UNITED STATES PATENT AND TRADEMARK OFFICE

APPLICATION NO.	FILING DATE	FIRST NAMED INVENTOR	ATTORNEY DOCKET NO.	CONFIRMATION NO.
10/782,574	02/18/2004	Ho Lu	JCLA12196	4739
23900	7590	08/18/2005	EXAMINER	
J C PATENTS, INC. 4 VENTURE, SUITE 250 IRVINE, CA 92618			KOVAL, MELISSA J	
			ART UNIT	PAPER NUMBER
			2851

Office Action Summary

DETAILED ACTION

FIG. 4 (PRIOR ART)

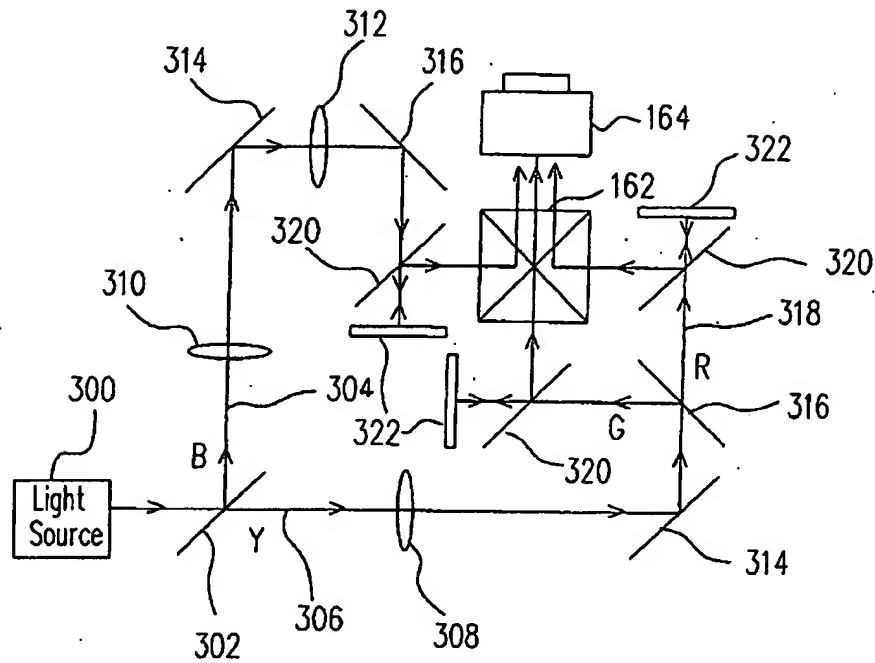
Please amend Figures 4, 7, 9, 10 and 11 as shown in red ink in the separate accompanying pages. Proposed corrected drawing including corrected Figures 4, 7, 9, 10 and 11 is also attached hereto in separate accompanying pages. Reconsideration is respectfully requested.

*Drawing
Corrections
approved
for entry
MSK
8/15/05*

FIG. 12

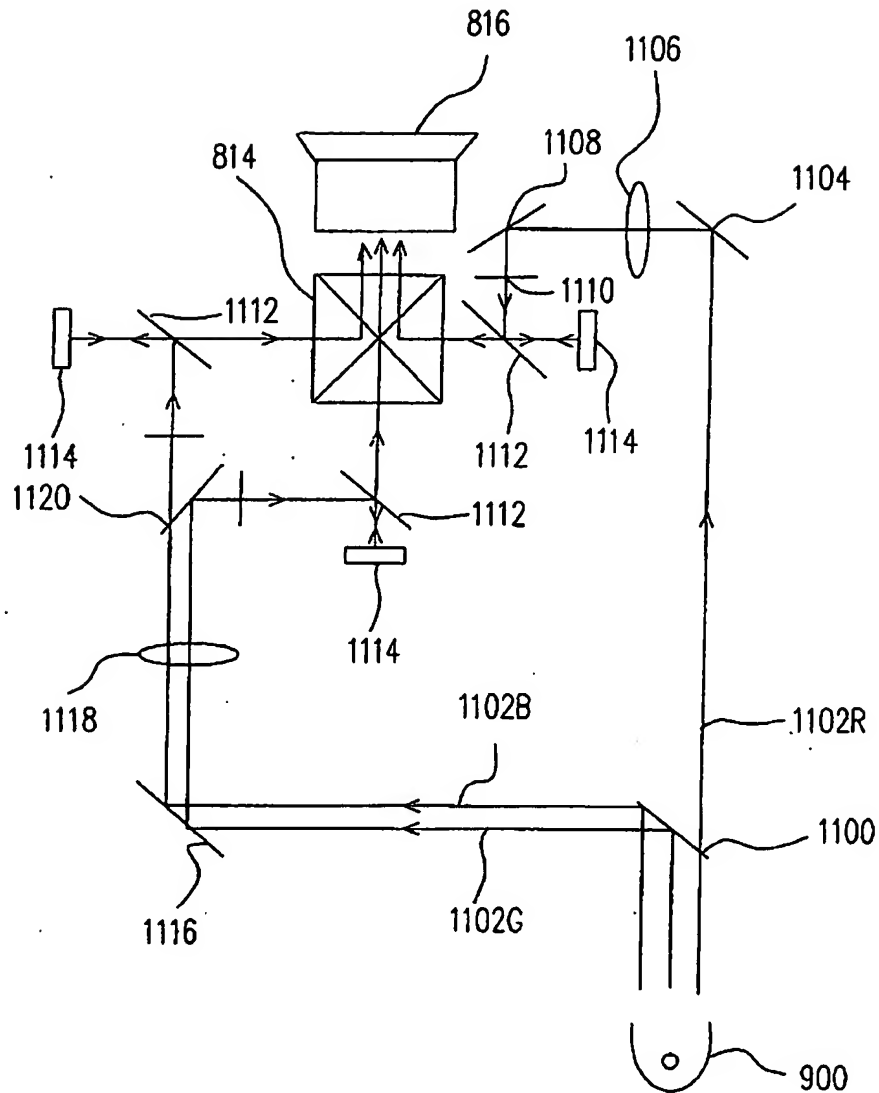
The drawings were received on July 20, 2005. These drawings are approved. Note with respect to page 2 of Applicant's remarks filed on July 20, 2005, the section titled "In the Drawings", Applicant refers to Figures 4, 7, 9, 10 and 11, only, therein. However the actual replacement Sheets of Drawings also include changes to Figure 12.
